Department of Environmental Quality

Re: WQ: Variance Approval: 248-25-000275-VAR: 11515 NW Dove Road; T.14S; R.12E; Sec. 3D;
Tax Lot 2800; 4.77 Acres; Deschutes County.

**Schedule A – Sky View Holdings LLC
Variance Report - Special Conditions
T 14S, R 12E, Sec: 3D, TL 2800**

Figure 3A. Modified Bottomless Sand Filter Section – Initial

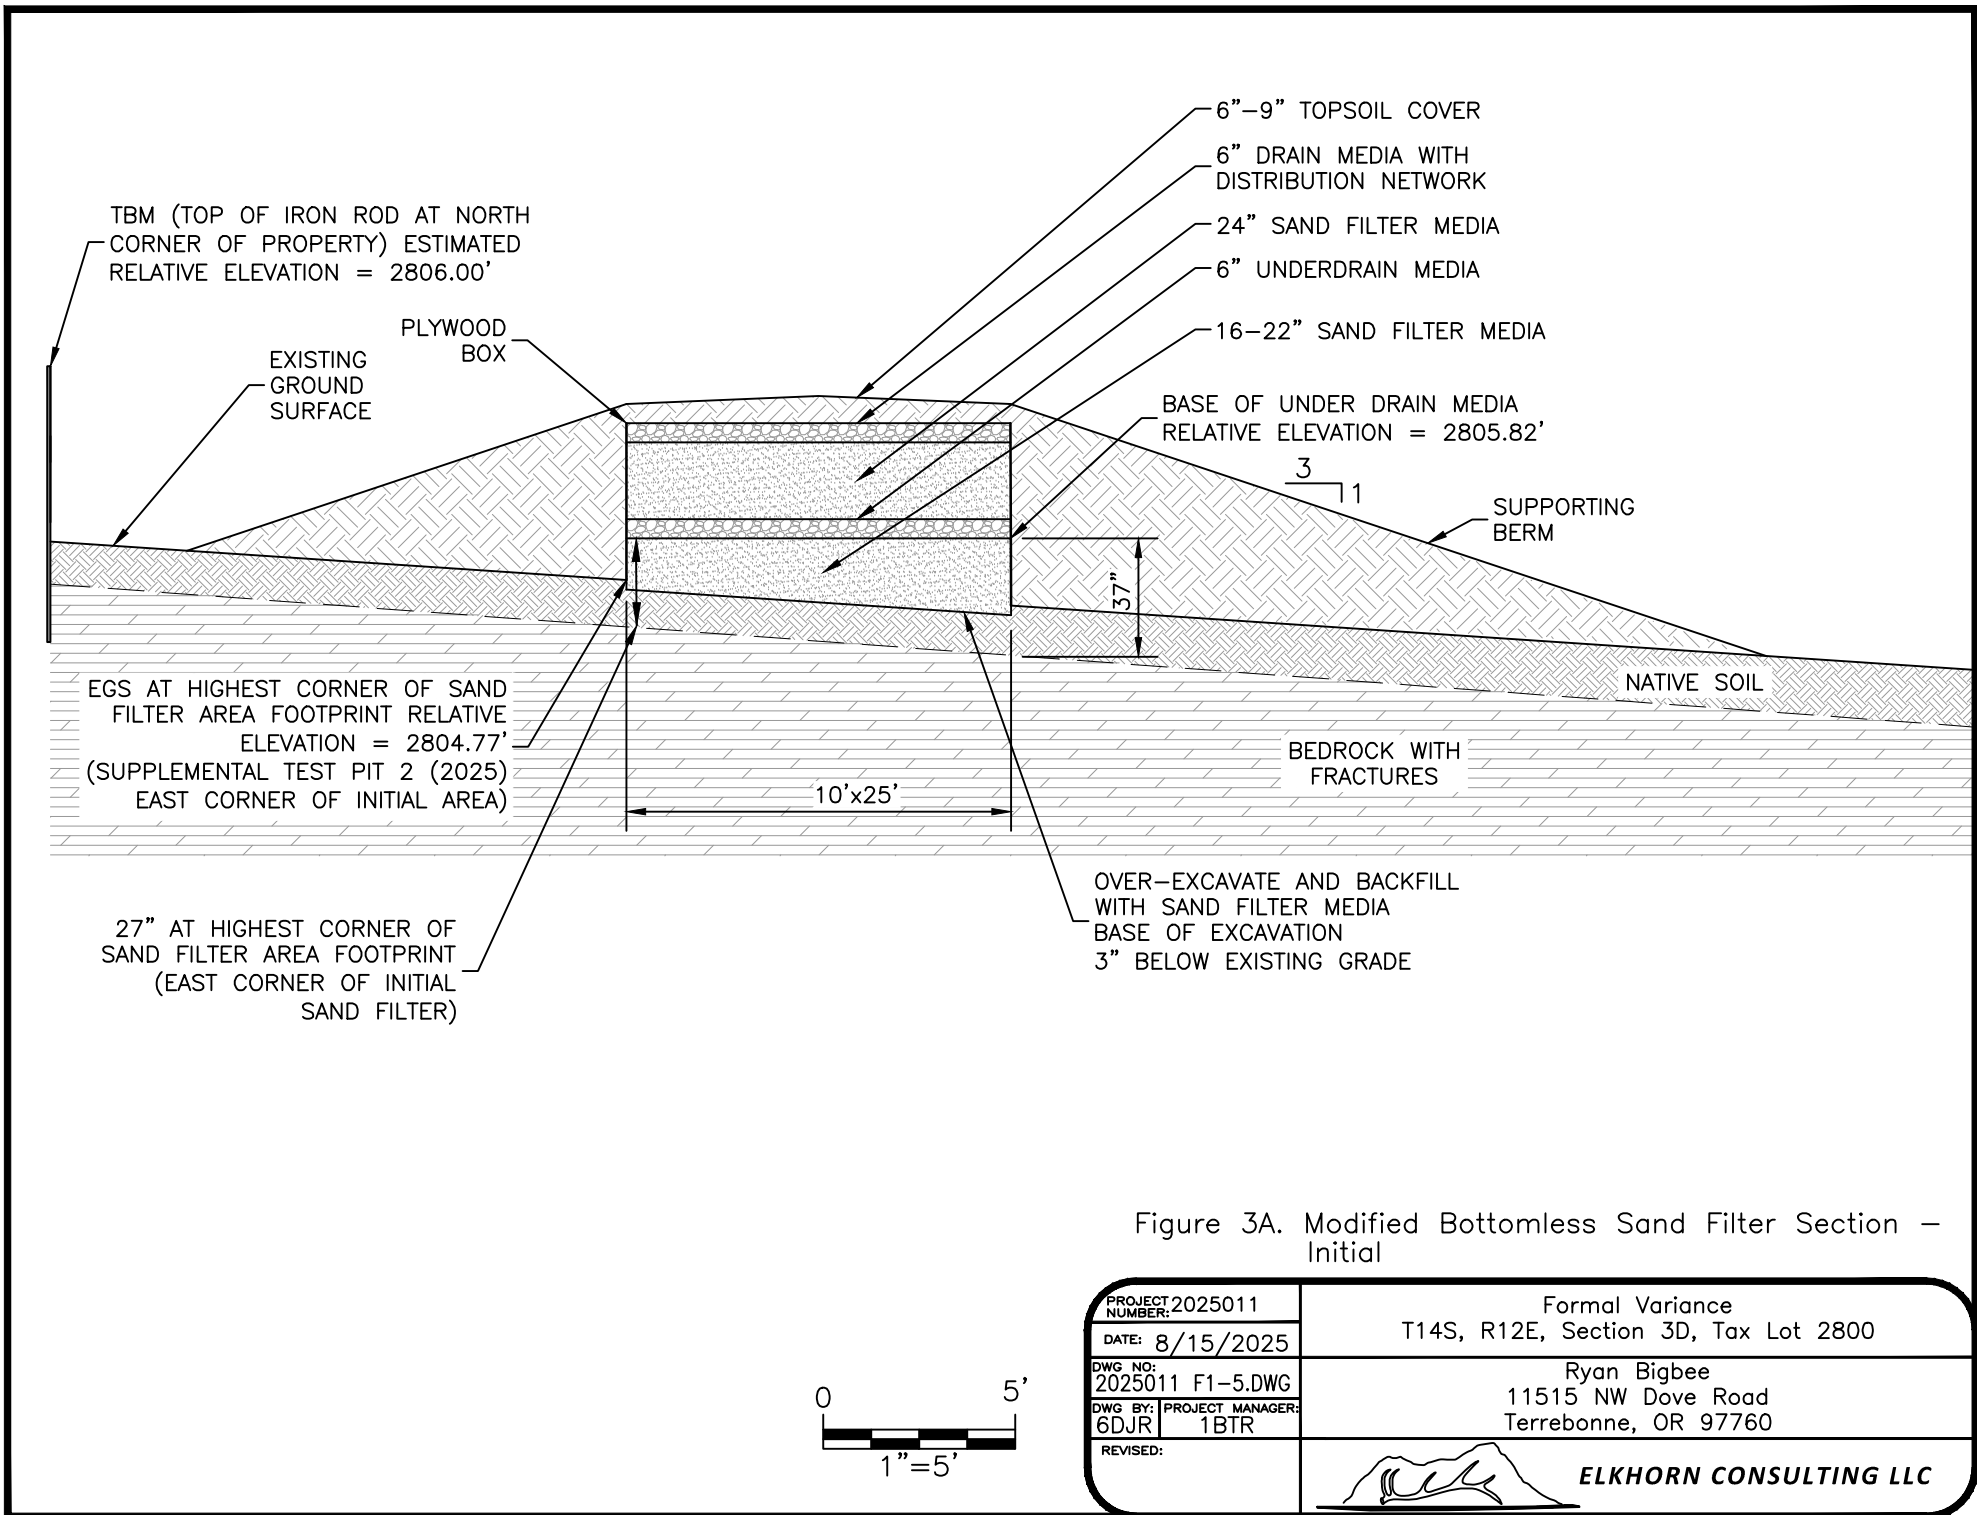
The proposed system seeks to overcome this limitation by elevating a 250-square foot modified bottomless sand filter in a manner that provides 3 inches more than the required minimum of 24 inches from the highest level of the underlying bedrock at the highest corner of each sand filter and substantially more (an additional 9 inches or more for the initial sand filter and 10 inches or more for the replacement sand filter) in the lowest corner (Figures 3A and 3B). The sod and underlying

sandy soil, along with any surface rock, to a depth of at least 3 inches within the footprint of the sand filter will be excavated and replaced with up to 16 inches or 19 inches of sand filter media at the high corner of the initial and replacement sand filters, respectively. This will be used to exceed the minimum 24-inch separation from shallowest underlying bedrock by 3 inches. The additional sand filter media at the low corner of the initial and replacement sand filters, respectively, will provide a total separation of 36 inches or 37 inches, respectively. The base of the sand filter container (framed wooden box) is proposed to follow the surface (countersunk 3 inches) to provide uniform contact of the imported sand filter media with the underlying soil (Figure 5). The rest of the sand filter will be “conventional” from there up, consisting of 6 inches of underdrain media, 24 inches of sand filter media, 6 inches of drain media (with the distribution laterals), filter fabric, and 6 to 9 inches of topsoil cover.

inches into the native soil. The proposal addresses the 2-foot continuous soil limitation by adding the 8 to 14 inches of additional sand media, thereby providing a total vertical separation of 31 to 35 inches from the bottom of the system to the shallowest depth of bedrock. The rest of the sand filter will be “conventional” from there up, consisting of 6 inches of underdrain media, 24- inches of sand filter media, 6- inches of drain media (with the distribution laterals), filter fabric, and 6-9 inches deep of final backfill on top. The sand filter will be contained within a supporting berm with a slope no steeper than 3:1.
